**LAKE ARTHUR, GRAND LAKE, AND  
GULF INTRACOASTAL WATERWAY  
TMDLS FOR DISSOLVED OXYGEN,  
NUTRIENTS, AND AMMONIA**

April 19, 2002

SUBSEGMENTS 050402, 050701, 050602, AND 050702

FTN Associates, Ltd.  
3 Innwood Circle, Suite 220  
Little Rock, AR 72211

Figure 3.1. Vector diagram for LA-QUAL model.

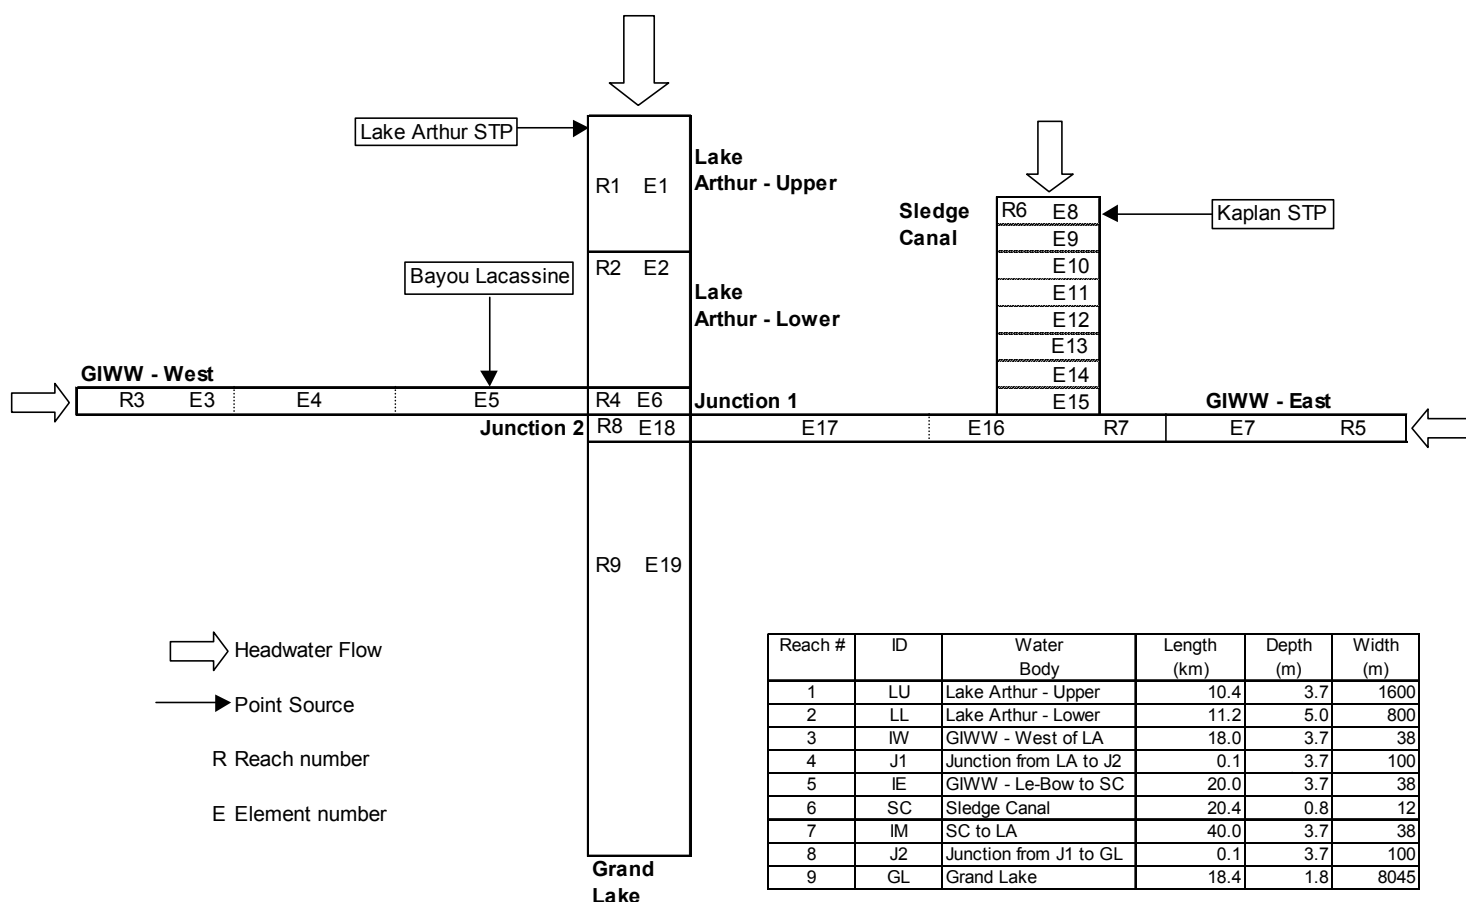
2. Figure 3.1, page 7: Certain reaches have discrepancies when compared to the calibration model input sets. Reach 8 is listed as "J2" in the figure and as "J3" in the model input. Reach 4's description does not correlate to any of the other two digit reach labels.

3. Figure 3.1, page 7: The width and length values listed in reach 9 could not be verified with the satellite imagery mapping available to LDEQ.

6. Figure 3.1, page 7: Certain reaches have discrepancies when compared to the calibration model input sets. Reach 8 is listed as "J2" in the figure and as "J3" in the model input. Reach 4's description does not correlate to any of the other two digit reach labels.

7. Figure 3.1, page 7: The listed width values do not match the actual widths in the calibration model output. The differentials are small, however, for consistency the values should match.

8. Figure 3.1, page 7: The width and length values listed in reach 9 could not be verified with the satellite imagery mapping available to LDEQ.

Response: The ID for reach 8 has been changed from J3 to J2 in the model. This has no effect on the model output.

Response: The width and length multiplied together yield a surface area of approximately 58 square miles, which appears to be correct.

Response: See response to comment 2 from LDEQ Specific Comments above.

Response: The differences are due to round-off when specifying velocity coefficients rather than width coefficients in data type 8.

Response: See response to comment 3 from LDEQ Specific Comments above.
